DEVIATION REVIEW AND DECISION FORM

Subdivision or Project Name: WindingWalk Filing No 1 at Meridian Ranch.

Section of ECM from which Deviation Is Sought: 2.3.3.F.3

BROKEN BACK CURVE DEVIATION
 PORCH SWING LANE
 WINDINGWALK FILING 1

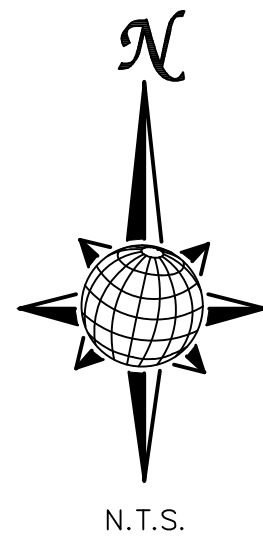
Proposed Nature and Extent of Deviation: The request for a deviation is to allow the proposed 163-foot-long centerline tangent length between the broken back curves on Porch Swing Ln – a Local street - at a location north of Stapleton Drive as shown on the plan and profile drawings.

Reason for the Requested Deviation: The shape and the topography of the site is formed by several constraints that cannot be mitigated, including the golf course and drainage channel to the west, Stapleton Drive adjacent to the to the south, an existing Meridian Service Metro District well to the north and the proposed access off Stapleton Drive at Lambert Road to the north. These constraints combined with the topography of the site significantly limit the options for street horizontal alignment. As a result, the 200-foot minimum tangent length is not achievable.

Comparison of Proposed Deviation to ECM Standard: The requested tangent length is 163 feet, which is 37 feet less than the ECM standard of 200 feet.

This request has been determined to have met the criteria for approval. A deviation from Section 2.3.3 of ECM is hereby granted based on the justification provided. Comments:
